SERVICE BULLETIN

CHECKING OF THE CRANKCASE

ON ROTAX® ENGINE TYPE 912 AND 914 (SERIES)

SB-912-029 R2
SB-914-018 R2

see fig. 1

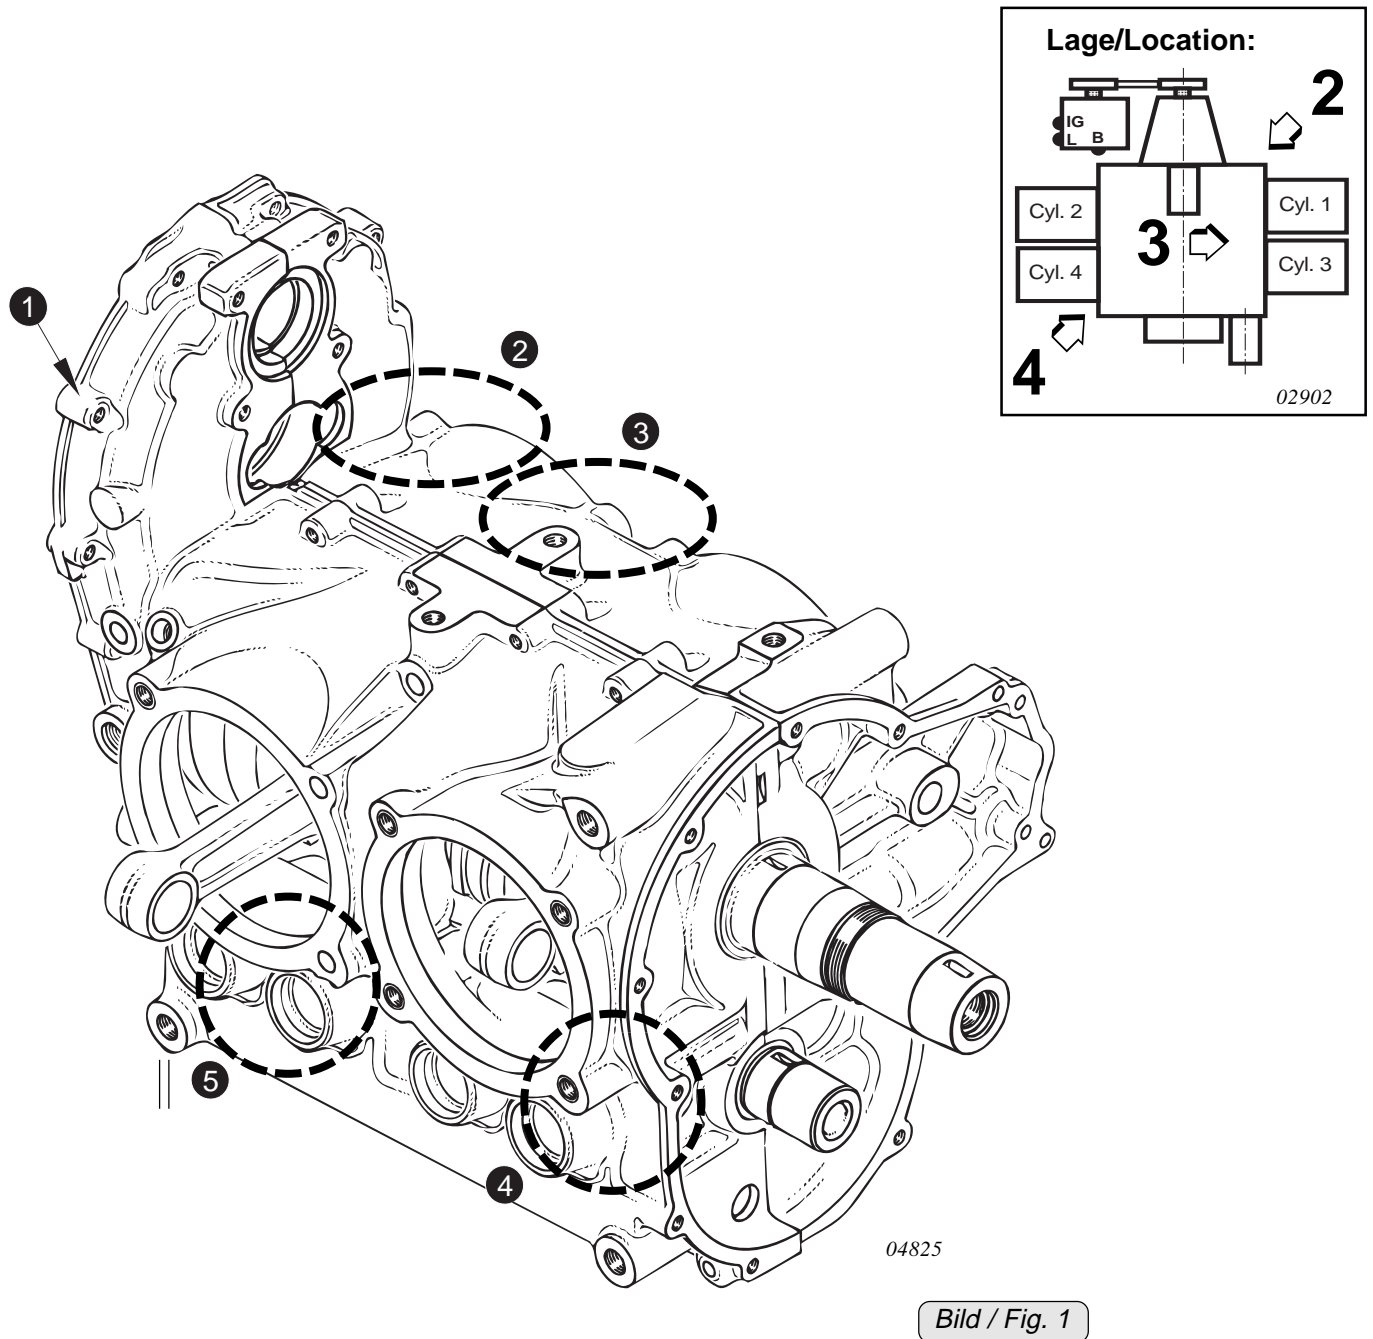
- Visually inspect the crankcase (1) and engine suspension for cracks in accordance with the relevant Maintenance Manual.

◆ **NOTE:** Scrutinize the crankcase for cracks especially in the area of cylinder 1 upper side (2), between cylinder 1 and 3 upper side (3), cylinder 4 lower side (4) and between the hydraulic valve tappet hole (5) of cylinder 2. See fig. 1.

For those engines using the ROTAX[®] cooling air baffle. Visually inspect for oil leaks in area (2) and (3). If leaks are found, then further investigation to determine the cause of the oil leak is required. If the exact origin of the leak can not be determined i.e. governor, then removal of the cooling air baffle may be required.

- If cracks are detected the nearest ROTAX[®] Authorized Distributor (see also our official ROTAX-Web-Site: www.rotax-aircraft-engines.com) has to be informed and if necessary the engine has to be removed from aircraft and must be returned to a ROTAX[®] Authorized Distributor.
- Reconnect negative terminal of aircraft battery (after installation of engine).
